FSN MA FCO-72000015 2020-Feb-17

URGENT - Field Safety Notice ***TraumaDiagnost***

Check of integrity for Trauma Arm

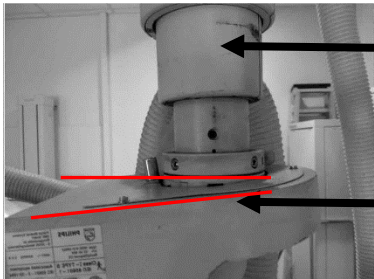
HOW TO IDENTIFY AFFECTED PRODUCTS	<p>An operator noticed an unusual angle of the trauma arm with respect to the telescopic column of the ceiling suspension.</p> <div style="display: flex; align-items: center;">  <div style="margin-left: 10px;"> <p>Telescopic column of ceiling suspension</p> <p>Supporting block</p> </div> </div> 
ACTION TO BE TAKEN BY CUSTOMER / USER	<p>The IfU (Instruction for Use) require the operator to not use the system and call for service, if a mechanical defect or malfunction is suspected.</p> <p>As soon as a deformation is determined, the system may no longer be used and call the service engineer.</p> <p>Should you feel uncertain regarding these instructions, please contact Philips.</p>
ACTIONS PLANNED BY PHILIPS	<p>The affected systems will be get an onsite check of the status of the Trauma arm for deformations as shown on the pictures.</p>
FURTHER INFORMATION AND SUPPORT	<p>If you would like any further information or support concerning this issue, please contact your local Philips representative.</p>
